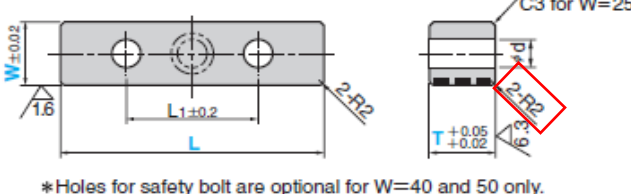
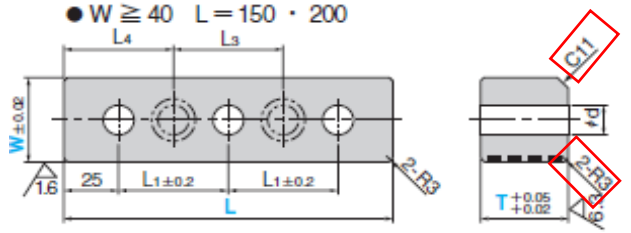
Page	Product	Wrong	Correct
165	MCSRG,MCSR W= 40・50, L=100	● W = 25 ● W = 40・50 and L=100  *Holes for safety bolt are optional for W=40 and 50 only.	 R chamfering C5 Chamfering 2-R2~3
	MCSRG,MCSRW W= 40 or more, L=150・200	● W ≥ 40 L = 150・200 	 R chamfering C5 Chamfering 2-R2~3
